Re: Application Number PL/2023/08088

We object to the proposed window on the grounds that:

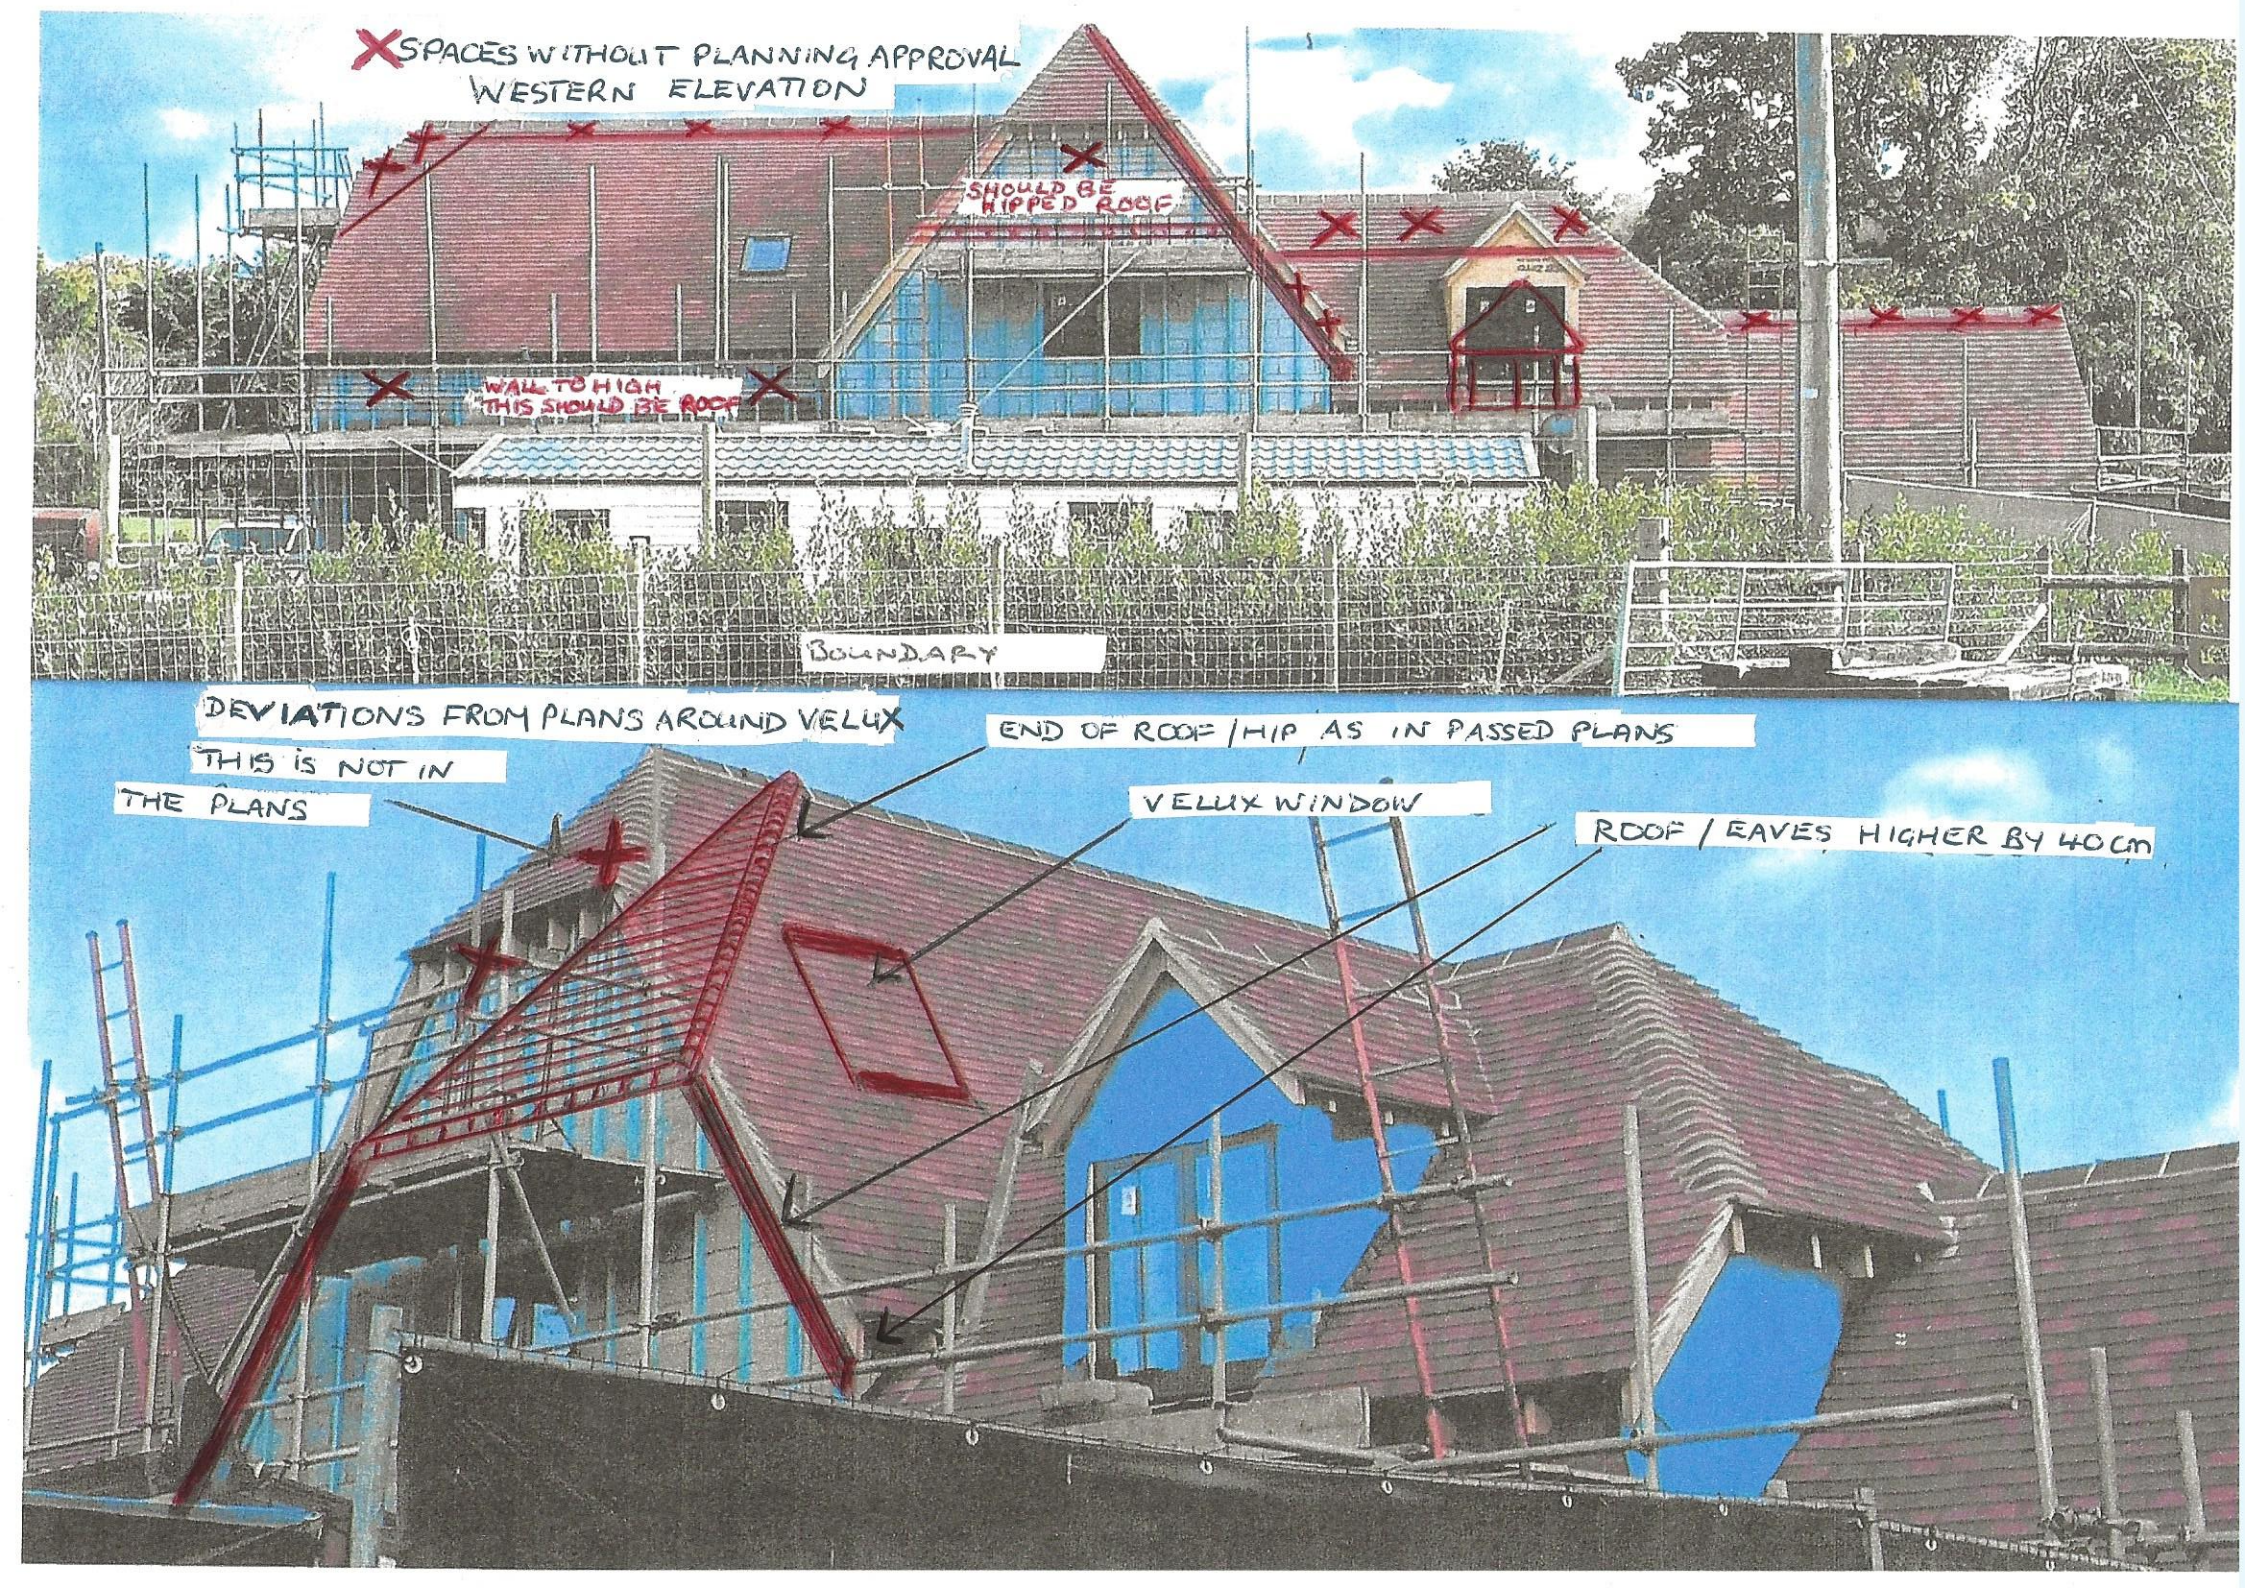
d) Due to un-approved changes to the roof hips, the internal space of the first floor has been considerably enlarged from the approved plans. Consequently part of the internal space for the en suite requiring this new rooflight has no planning permission and breaks the conditions. Please see Attachment 1.

f) If the roof were constructed according to the plans the proposed window would be impracticably close to the hip. Please see Attachments 1 and 2.
g) This application also affects Condition 4 (which is not listed on the application form)

END OF ROOF / HIP AS PLANS
VELUX APPLIED FOR
FINISHED ROOF HEIGHT

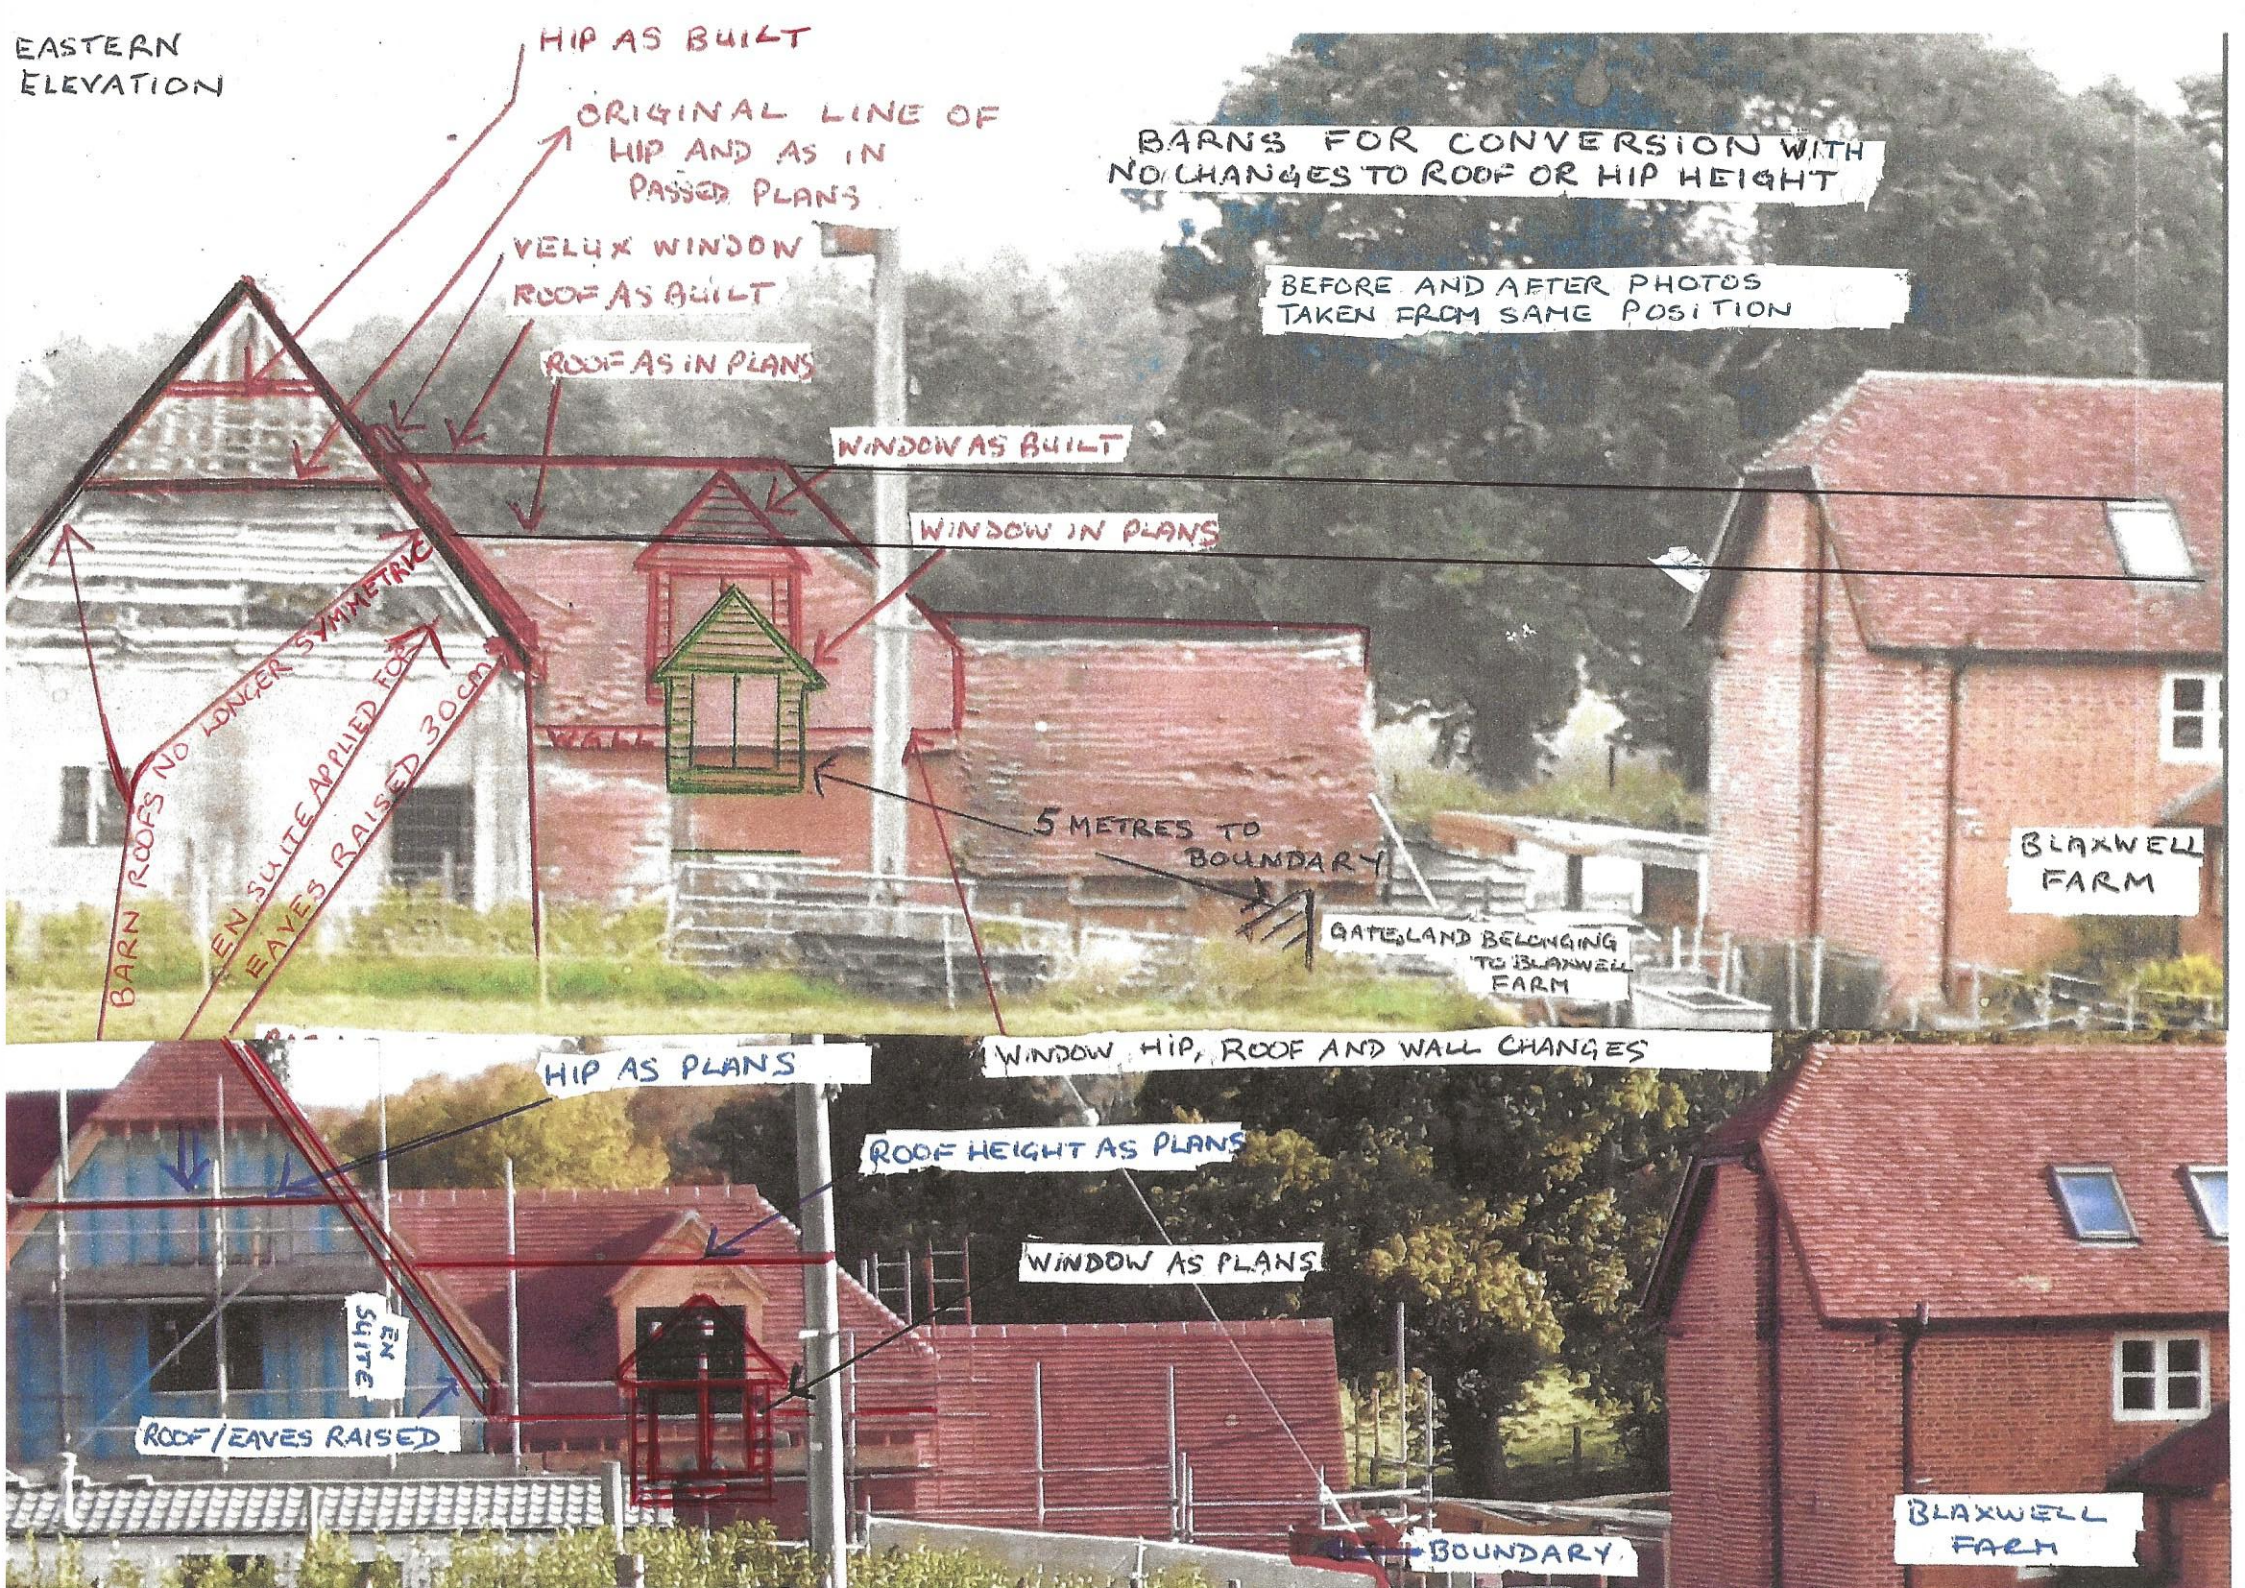
e) Contrary to the approved plans, the eaves under the proposed window have been raised by 40cm by increasing the wall height and thereby also raising the internal skeiling ceiling. These deviations have enabled the low area on the original upstairs floor plan to become the potential en suite. Please see Attachment 2.

X SPACES WITHOUT PLANNING APPROVAL
WESTERN ELEVATION
SHOULD BE HIPPED ROOF
WALL TO HIGH THIS SHOULD BE ROOF
BOUNDARY
DEVIATIONS FROM PLANS AROUND VELUX
THIS IS NOT IN THE PLANS
END OF ROOF / HIP AS IN PASSED PLANS
VELUX WINDOW
ROOF / EAVES HIGHER BY 40 cm

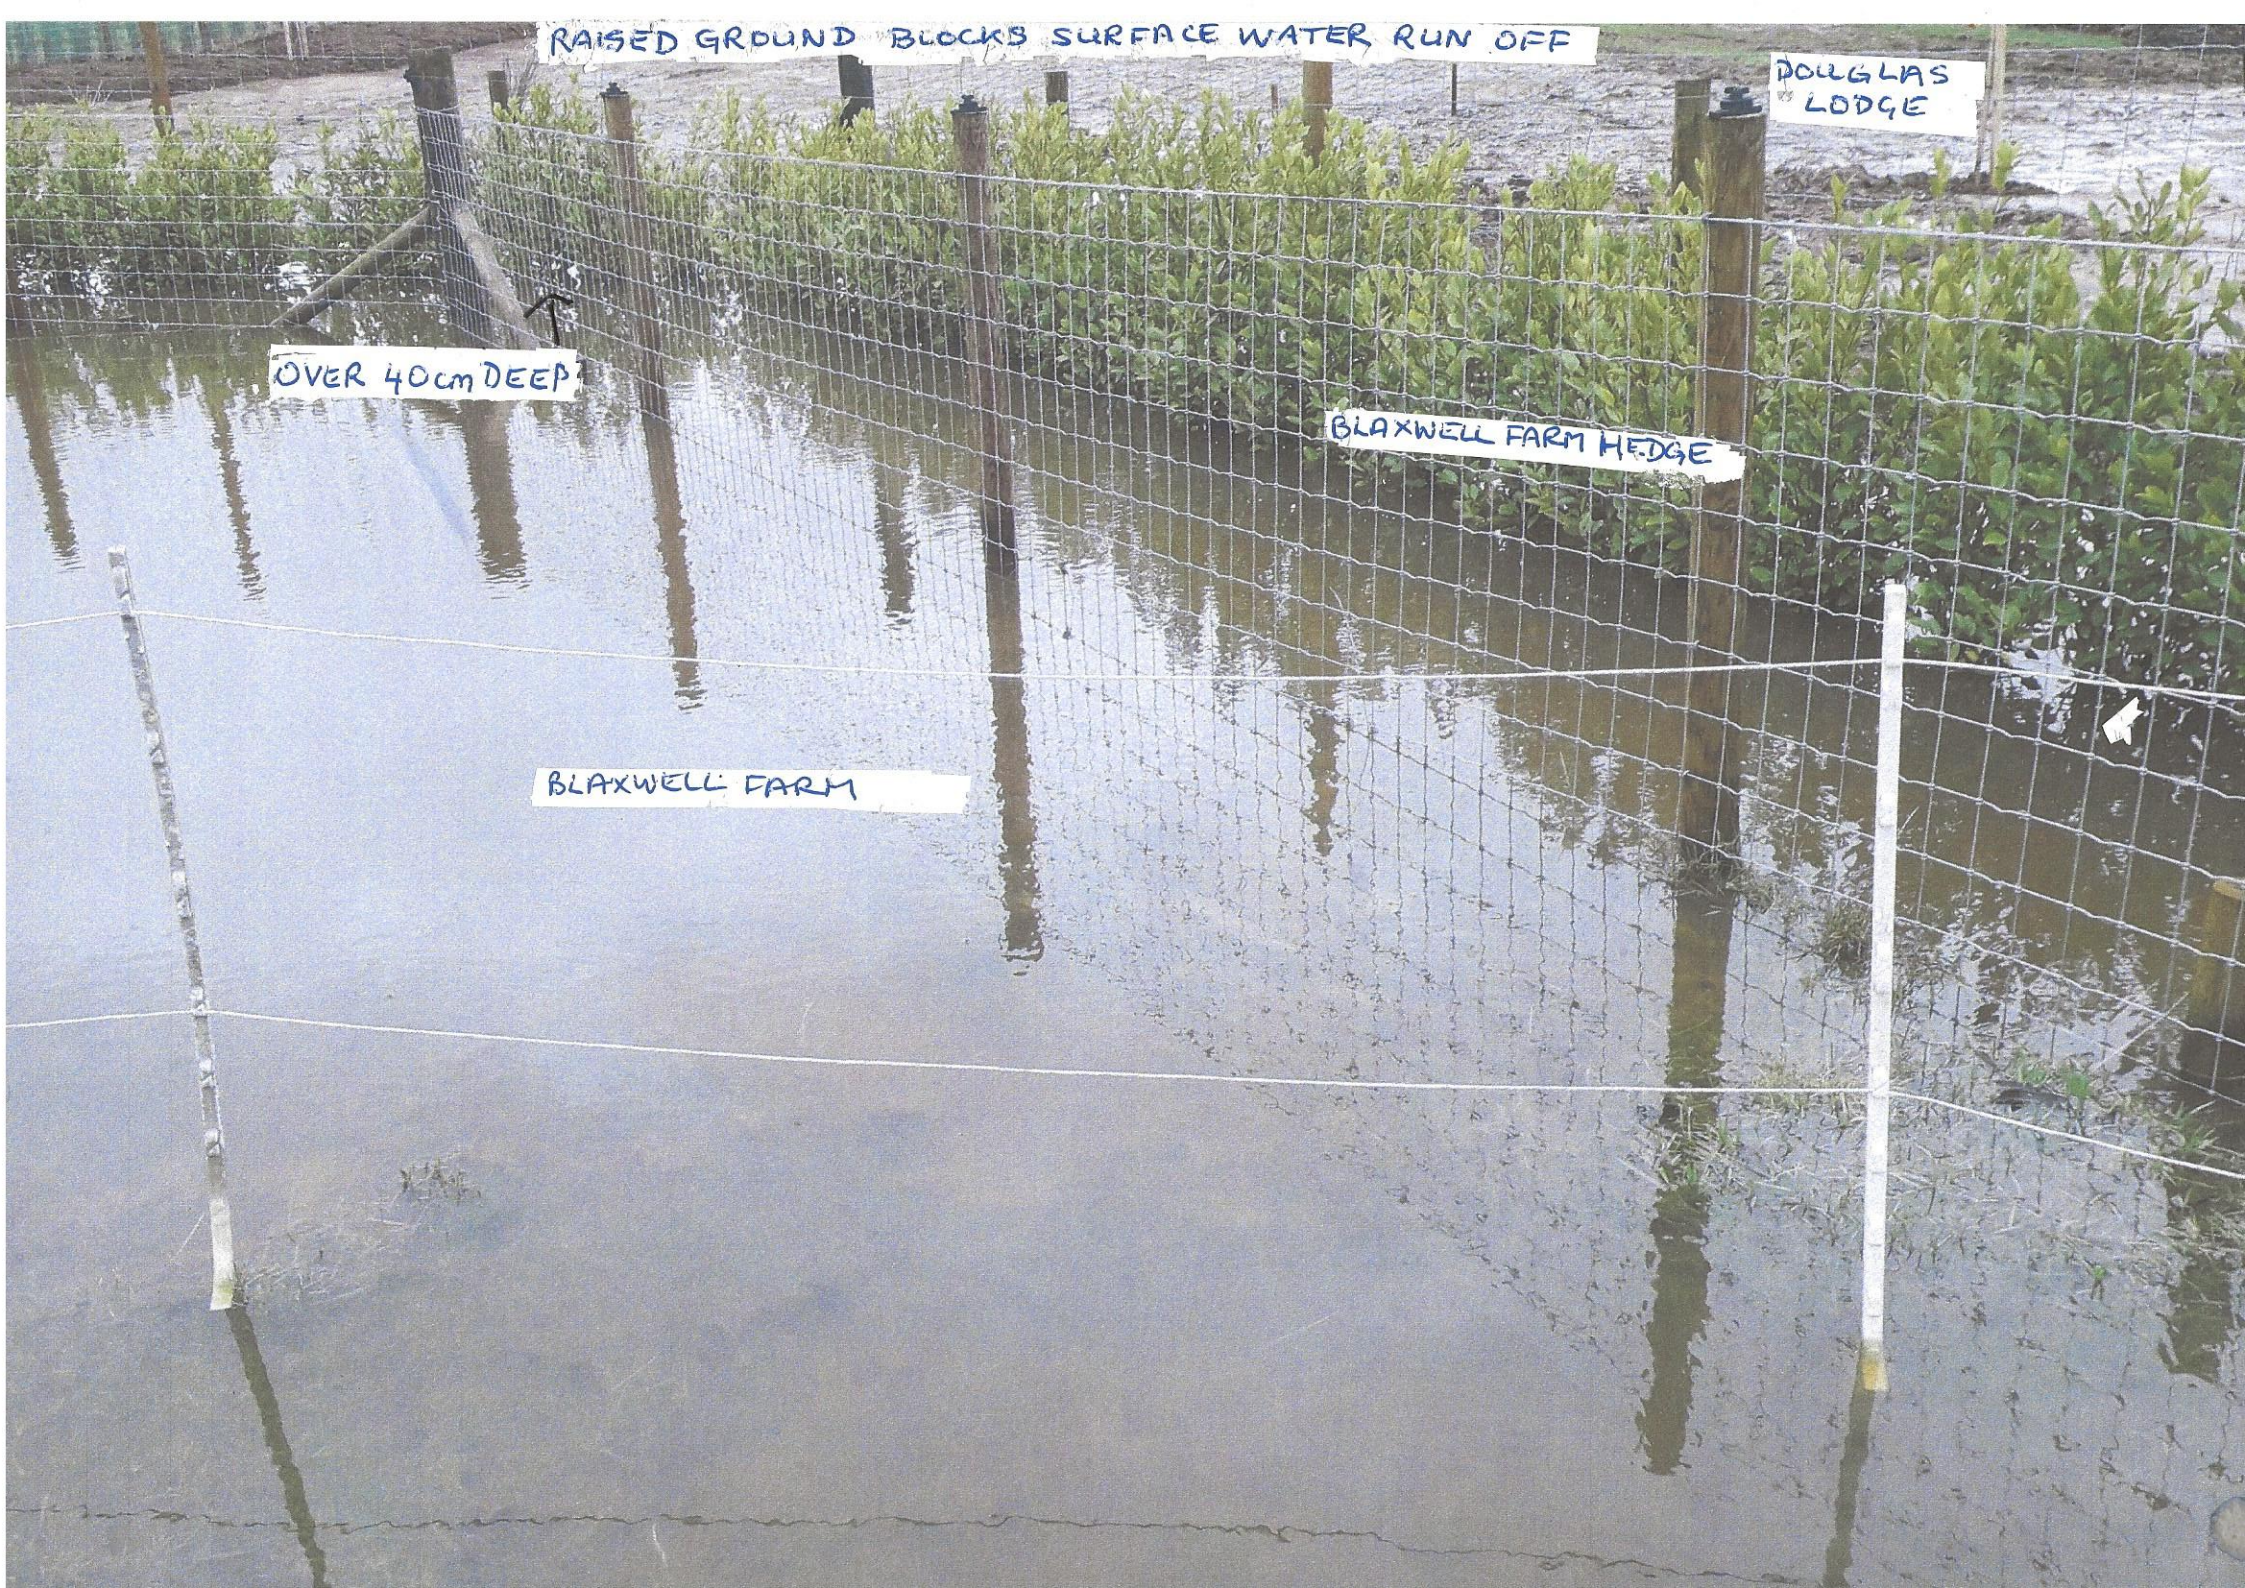
a) Nearly all the roofs are higher, walls are higher and hips are smaller. These changes vastly increase the internal space and the external bulk of the building. See Attachments 3 and 2.

EASTERN ELEVATION
HIP AS BUILT
ORIGINAL LINE OF HIP AND AS IN PASSED PLANS
VELUX WINDOW
ROOF AS BUILT
ROOF AS IN PLANS
WINDOW AS BUILT
WINDOW IN PLANS
BARNS FOR CONVERSION WITH NO CHANGES TO ROOF OR HIP HEIGHT
BEFORE AND AFTER PHOTOS TAKEN FROM SAME POSITION
BARN ROOFS NO LONGER SYMMETRIC
EN SUITE APPLIED FOR
EAVES RAISED 30cm
5 METRES TO BOUNDARY
GATELAND BELONGING TO BLAXWELL FARM
BLAXWELL FARM
HIP AS PLANS
WINDOW, HIP, ROOF AND WALL CHANGES
ROOF HEIGHT AS PLANS
WINDOW AS PLANS
EN SUITE
ROOF/EAVES RAISED
BOUNDARY
BLAXWELL FARM
